# HISTORIC AND DESIGN REVIEW COMMISSION

July 06, 2018

**HDRC CASE NO:** 2018-303  
**COMMON NAME:** Print Building  
**ADDRESS:** 420 BROADWAY  
**LEGAL DESCRIPTION:** NCB 432 (SAN ANTONIO LIGHT), BLOCK 16 LOT 14  
**ZONING:** FBZ T6-1, HS, RIO-2  
**CITY COUNCIL DIST.:** 1  
**LANDMARK:** San Antonio Light Building  
**APPLICANT:** Peter French/Gray Street Partners  
**OWNER:** Graystreet 420 Broadway LLC  
**TYPE OF WORK:** Exterior modifications to the Print Building and the construction of a connector addition to the Light Building  
**APPLICATION RECEIVED:** June 15, 2018  
**60-DAY REVIEW:** August 14, 2018  
**REQUEST:**

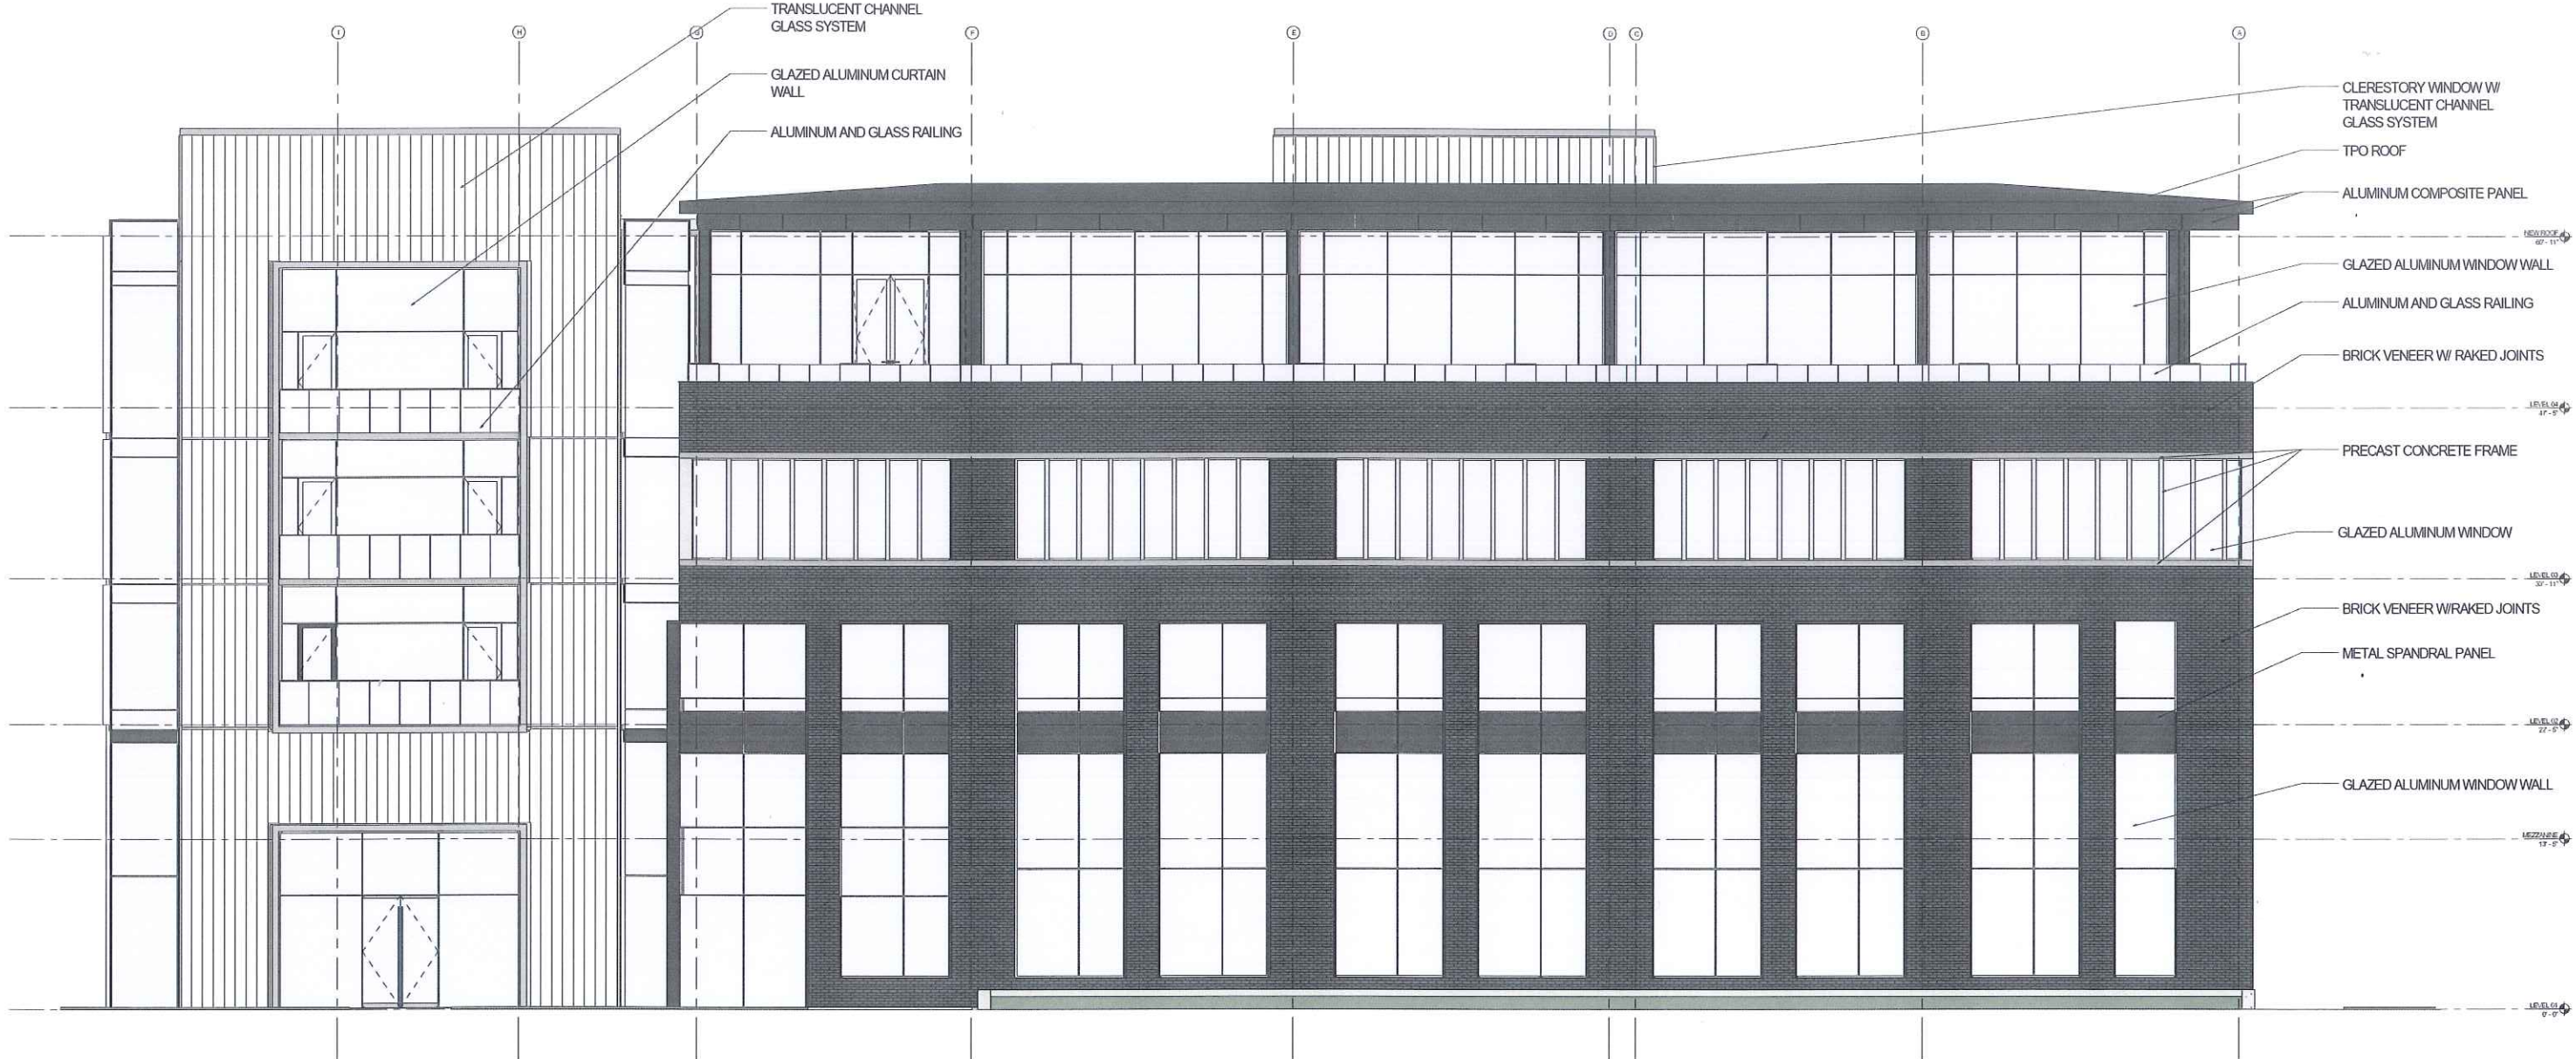
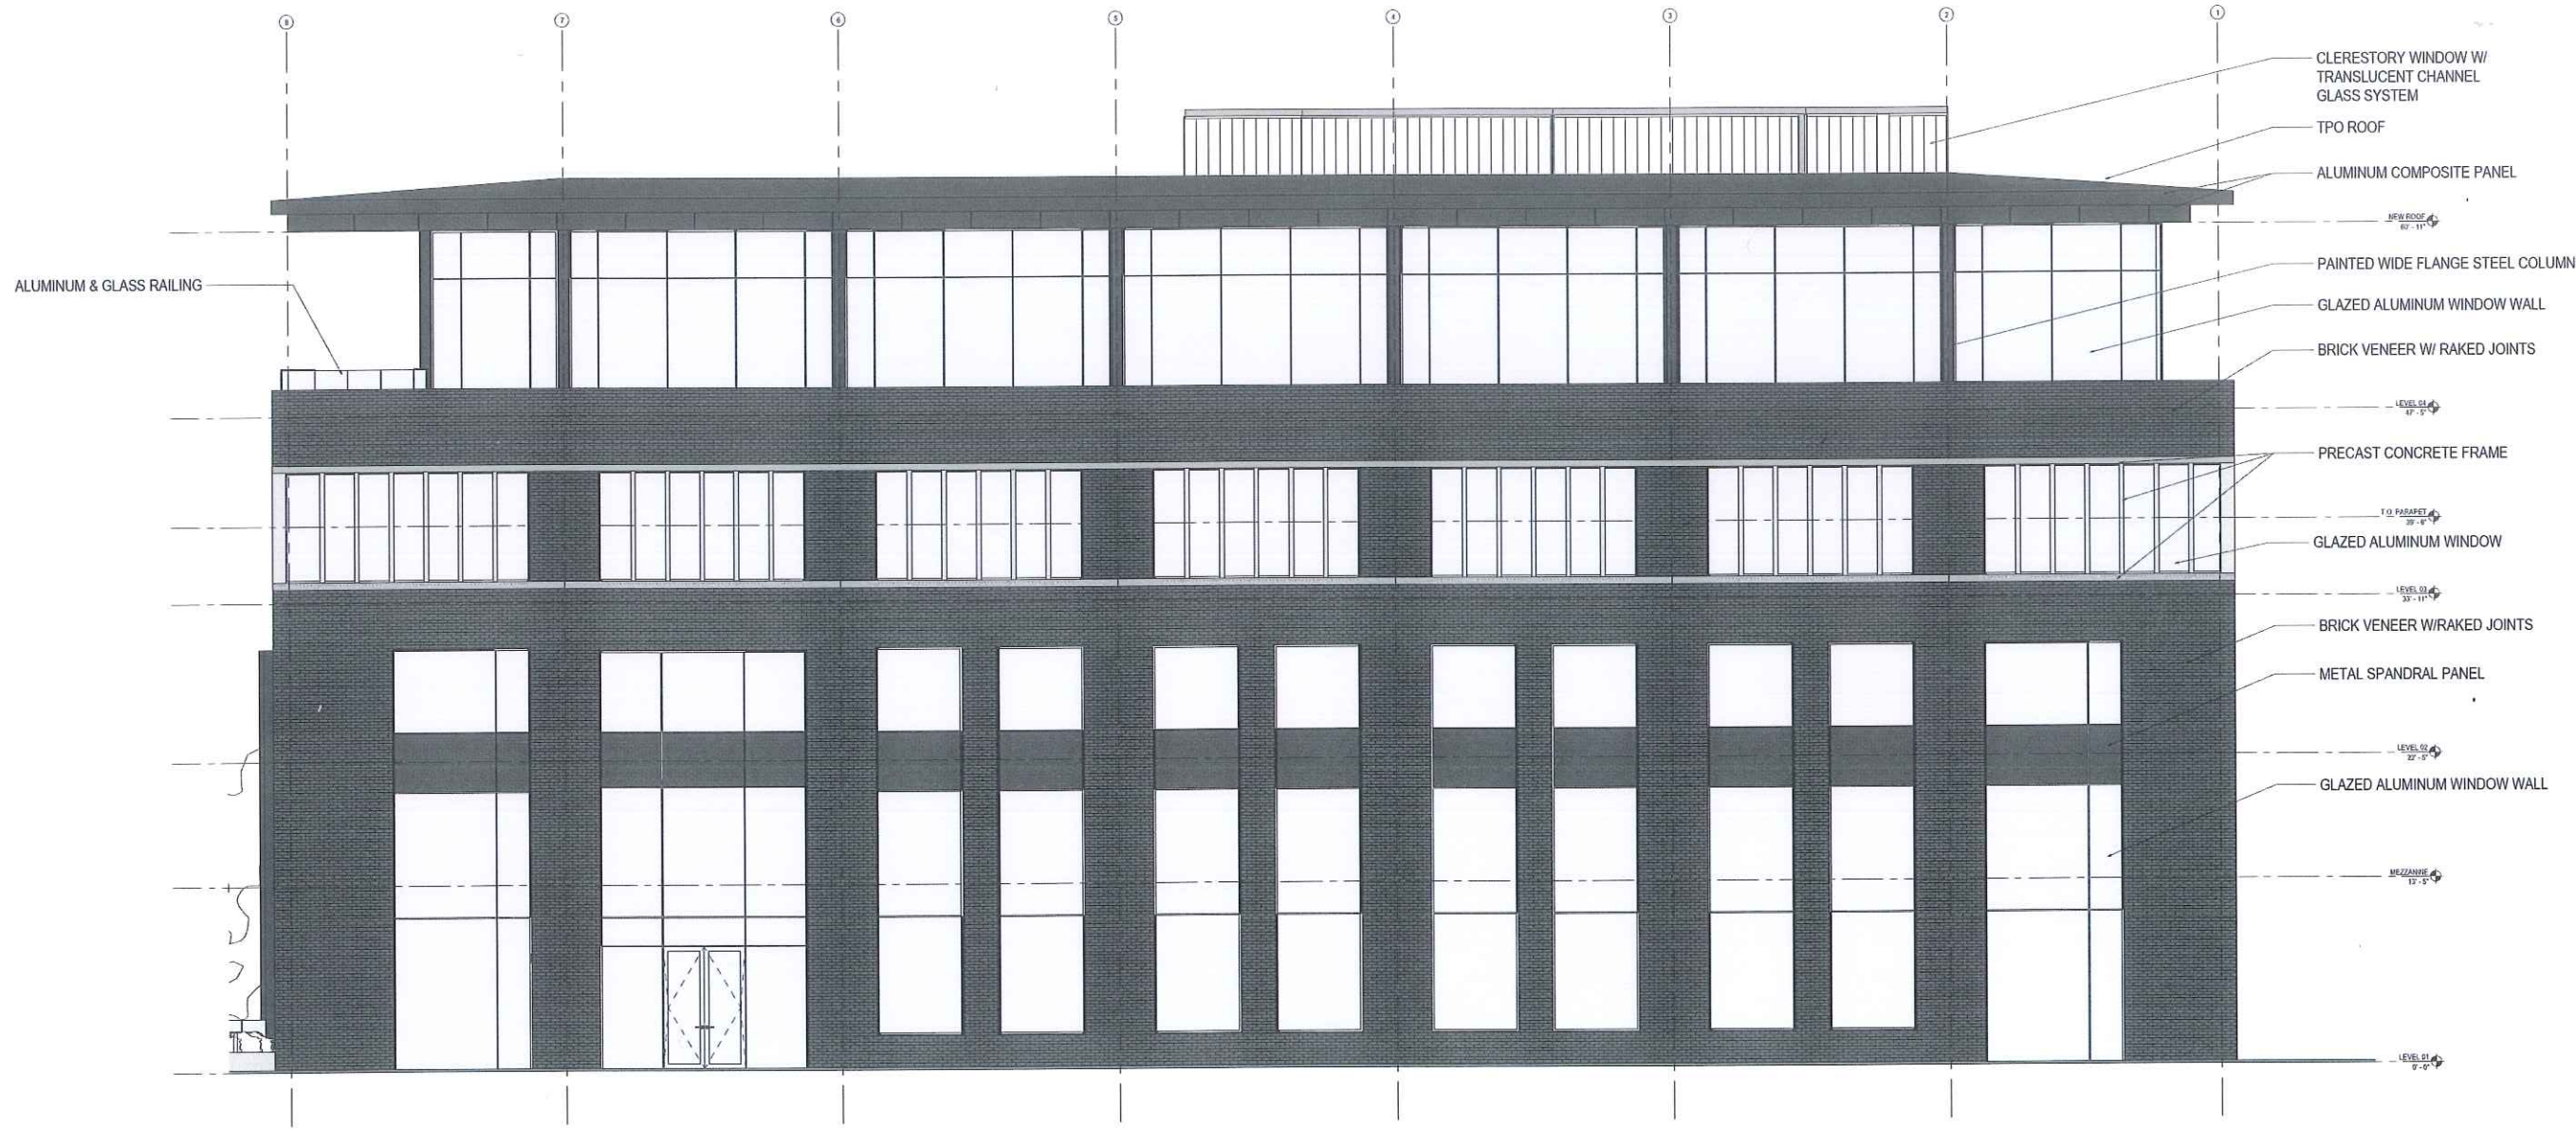
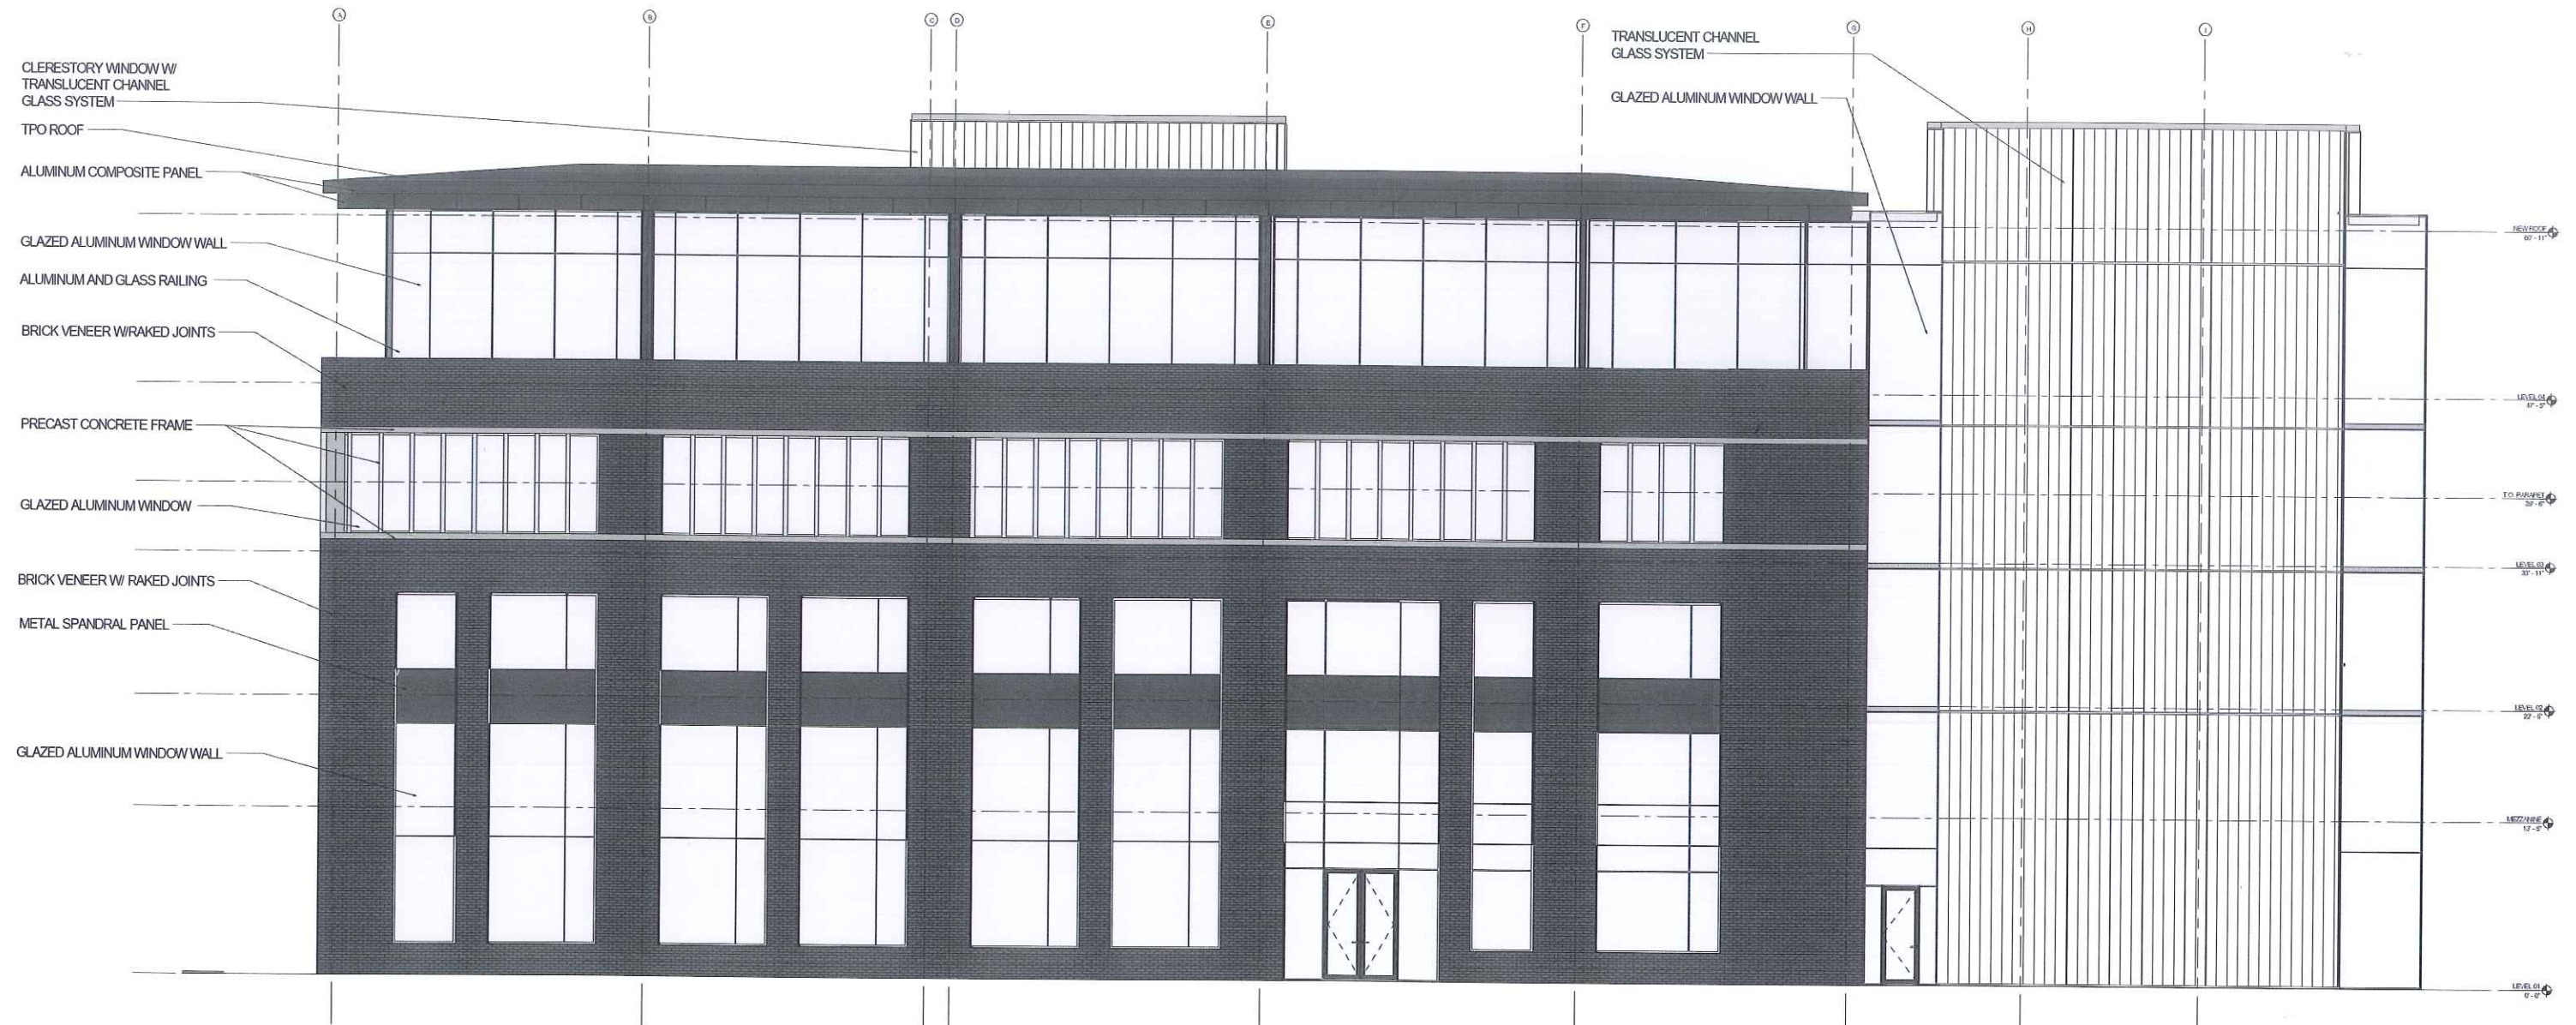
- f. **PRINT BUILDING MODIFICATIONS** – The Print Building currently features a tan brick façade with fenestration patterns framed by cast stone. The proposed modifications to the exterior of the structure would result in the removal of the structure’s currently fenestration pattern, brick and façade arrangement. The UDC Section 35-676 notes that every reasonable effort shall be made to adapt the property in a manner which requires minimal alteration of the building, structure, object, or site and its environment. The UDC also notes that the distinguishing original qualities or character of a building, structure, object, or site and its environment, shall not be destroyed. Per the Historic Design Guidelines, Guidelines for Exterior Maintenance and Alterations 10.A., character defining features of structures zoned historic should be preserved. The removal or alteration of any historic material or distinctive architectural features shall be avoided. Staff finds that the proposed façade modifications remove the distinguishing original qualities and character of the building and are not consistent with the Historic Design Guidelines and the UDC.

- g. **PRINT BUILDING MODIFICATIONS** – As noted in finding f, character defining features should be preserved. The Guidelines for Exterior Maintenance and Alterations 10.B.i. notes that new features should not be introduced that alter or destroy the historic building character, such as such as adding inappropriate materials; altering the size or shape of windows, doors, bulkheads, and transom openings; or altering the façade from commercial to residential. Staff finds that the proposed modifications are inconsistent with the Guidelines.

- h. **PRINT BUILDING ADDITION** – The applicant has proposed an addition of two levels to the rooftop of the Print Building. The UDC Section 35-676 notes that new additions shall be done in such a manner that if such additions or alterations were to be removed in the future, the essential form and integrity of the building or structure would be unimpaired. Staff finds that the proposed addition’s massing and overall form are appropriate; however, the addition should feature an overall form and design that complements to existing architectural features of the building. Currently, the addition’s design is consistent with the proposed modifications, which are not consistent with the UDC.

1. Staff does not recommend conceptual approval of item #1, exterior modifications to the Print Building based on findings f and g. Staff recommends that the applicant adhere to the UDC and modify the structure within the existing design.

2. Staff does not recommend conceptual approval of item #2, the proposed rooftop addition based on finding h. Staff finds that an addition may be appropriate; however, the addition should feature an overall form and design that complements to existing architectural features of the building. Currently, the addition's design is consistent with the proposed modifications, which are not consistent with the UDC.
